OBLIVIOUS MONKEY GAMING

PL202000054

8070 MORGAN CIRCLE DRIVE SOUTH, BLOOMINGTON, MN 55431

LIFE SAFETY PLAN
/ CODE REVIEW

1 LIFE SAFETY PLAN - LEVEL 01
1/8" = 1'-0"

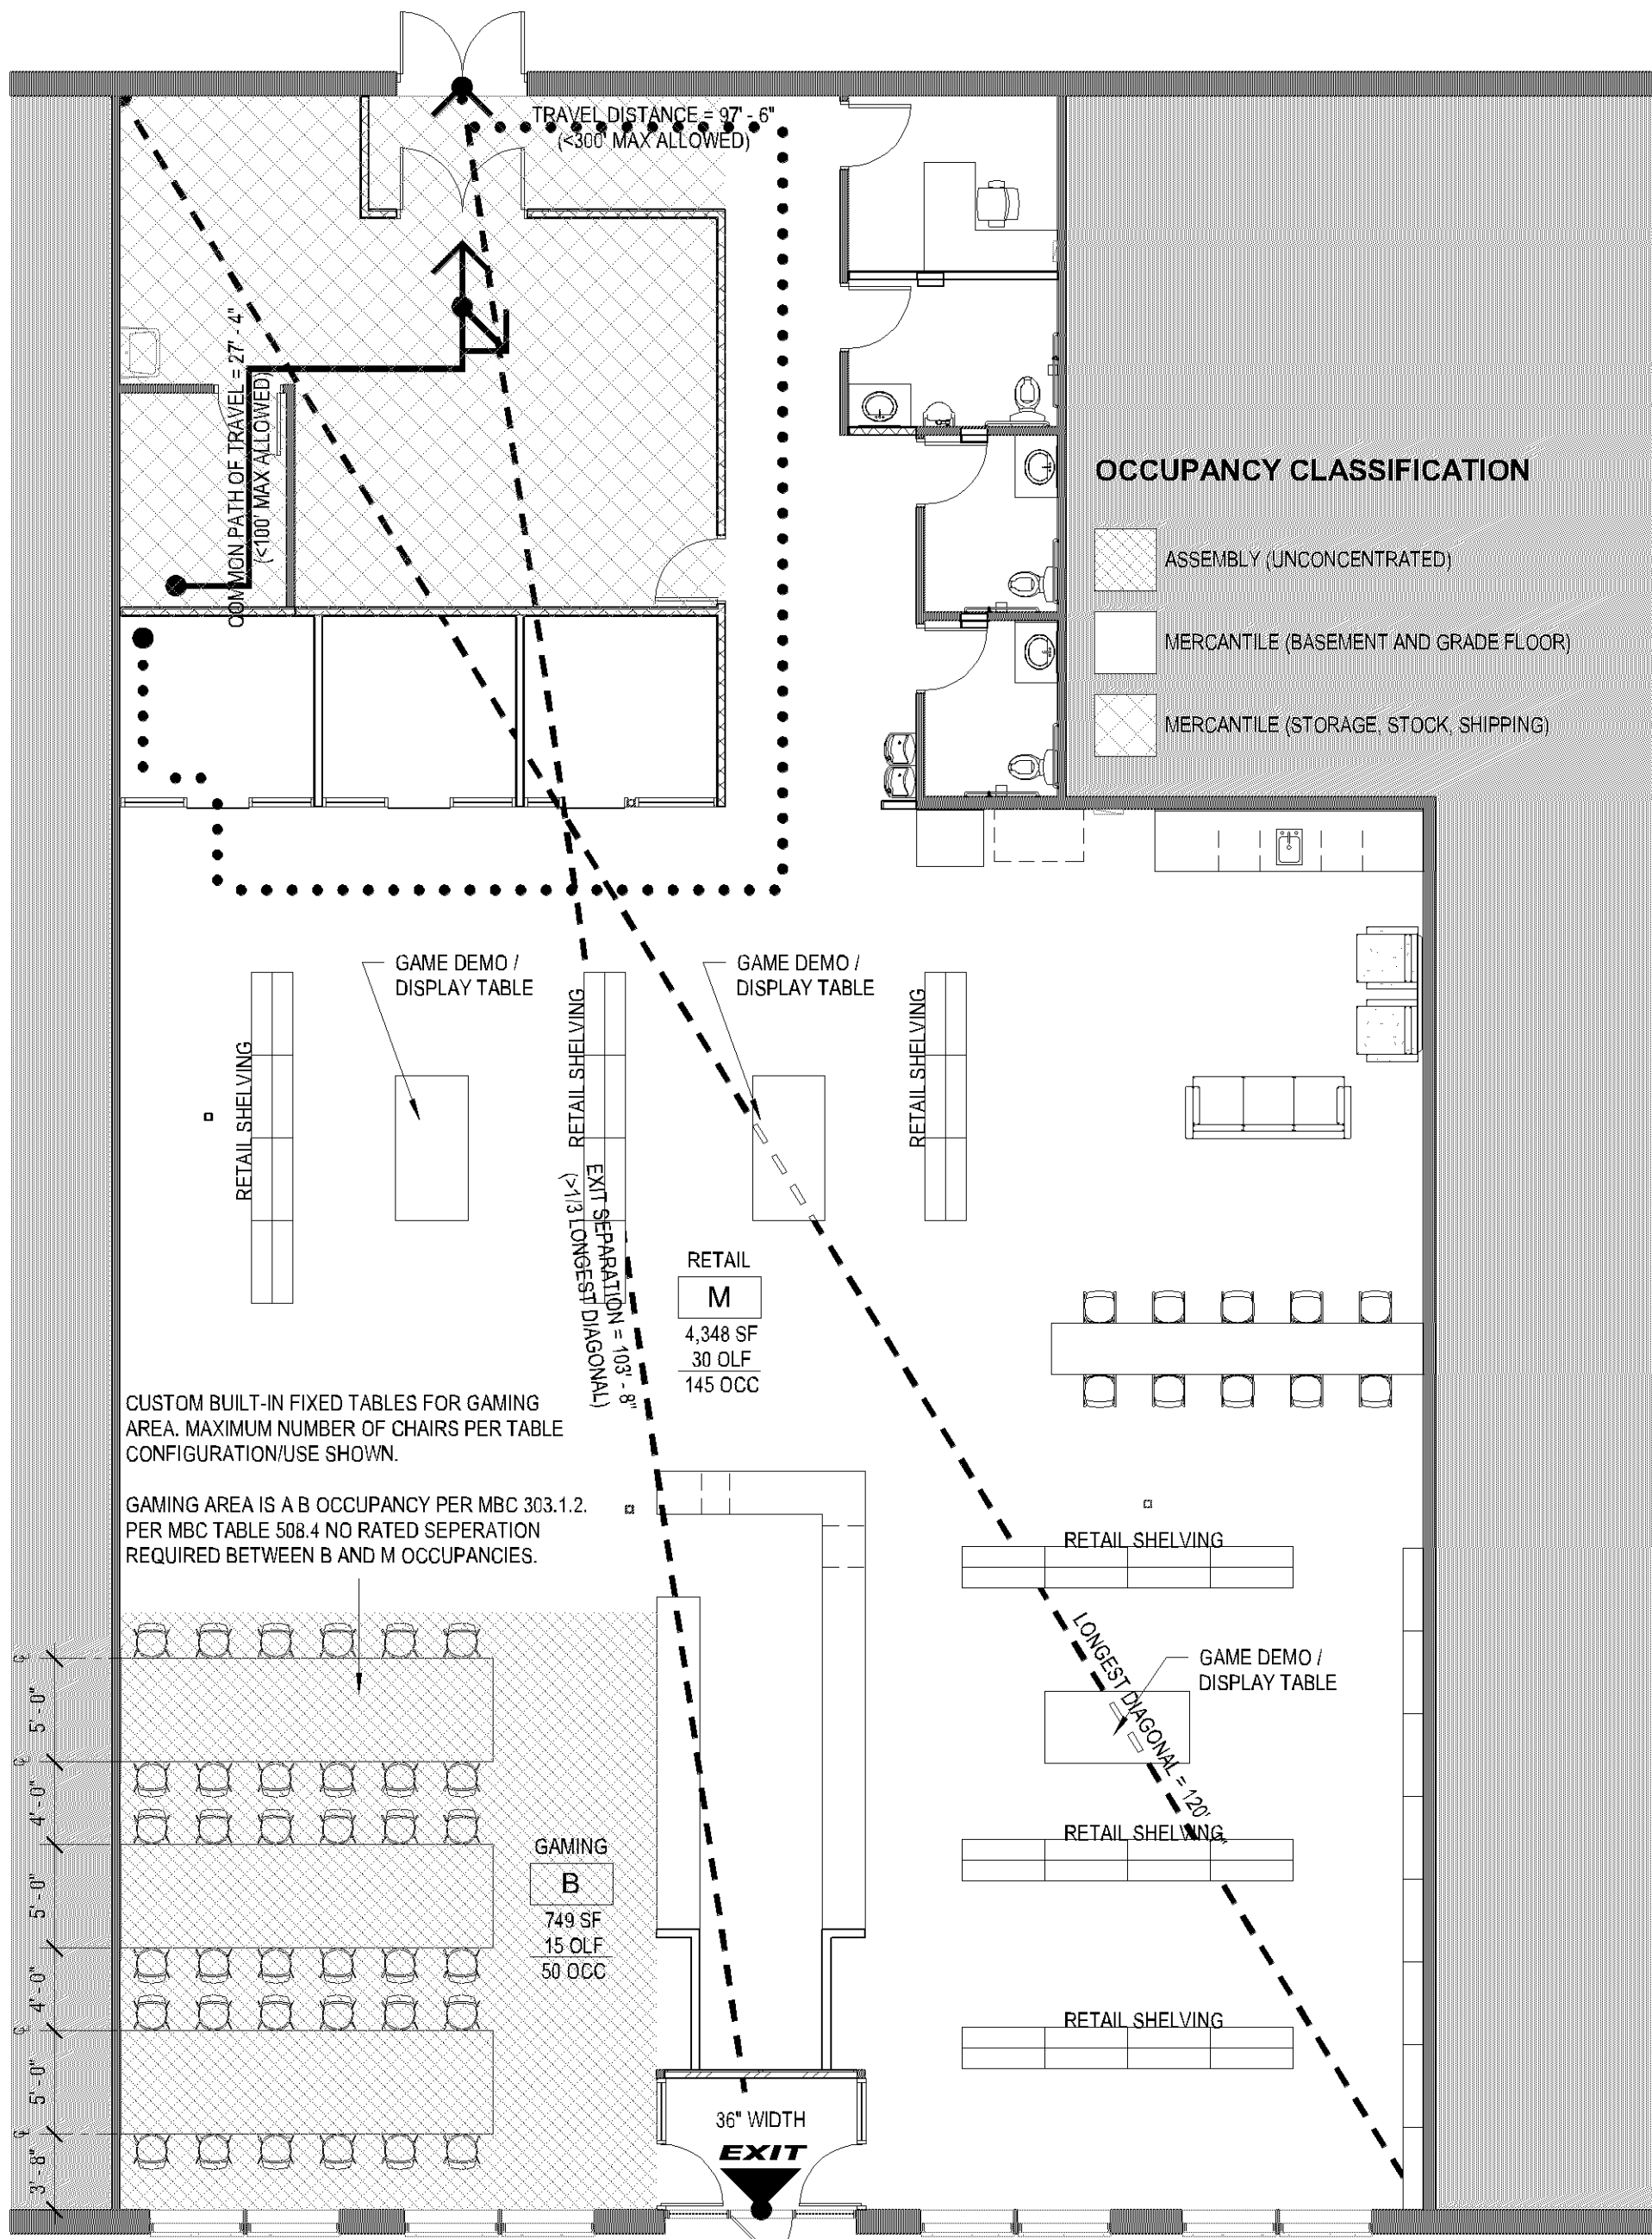
Provide an Environmental Health Plan Review Application

Provide details of food service operation and submit application with all details listed here.

Trash and recycling storage must comply with Section 21.301.17 of the City Code.

Provide floor, wall and ceiling finish schedule of kitchen and service area
